INFORMATIONAL PCN #: 2344

PCN Title: Carrier tape orientation

Image 1, change From orientation

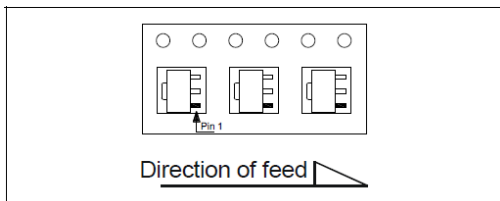
Notification Date:	Implementation Date:	Product Family:	Change Type:	PCN #:
24 May, 2018	24 June, 2018	Discrete	Carrier tape orientation	2344
TITLE				
Carrier tape orientation				
DESCRIPTION OF CHANGE				
<p>This change has no impact on product quality, reliability, electrical or mechanical performance. Affected products will remain fully compliant to all published specifications.</p> <p>This PCN is being issued to notify the customer that products listed in Table 1 below will have a correction of the physical orientation of the affected parts within the carrier tape to be aligned with our SMD Packaging specification (https://www.diodes.com/assets/Diodes-Packaging/ap02007.pdf). The orientation change is described in image 1 and image 2 below. The change will be implemented on or about Date Code 1826.</p> <p>There is no change to fit, form, or function of the affected products. No other changes beside the ones outlined in this PCN will be implemented as part of this PCN release.</p>

IMPACT				
Carrier tape orientation change				
PRODUCTS AFFECTED				
See Table 1 below for the products affected.				
WEB LINKS				
Manufacturer's Notice:	https://www.diodes.com/quality/product-change-notices/diodes-product-change-notices/			
For More Information Contact:	http://www.diodes.com/contacts			
Data Sheet:	http://www.diodes.com/products
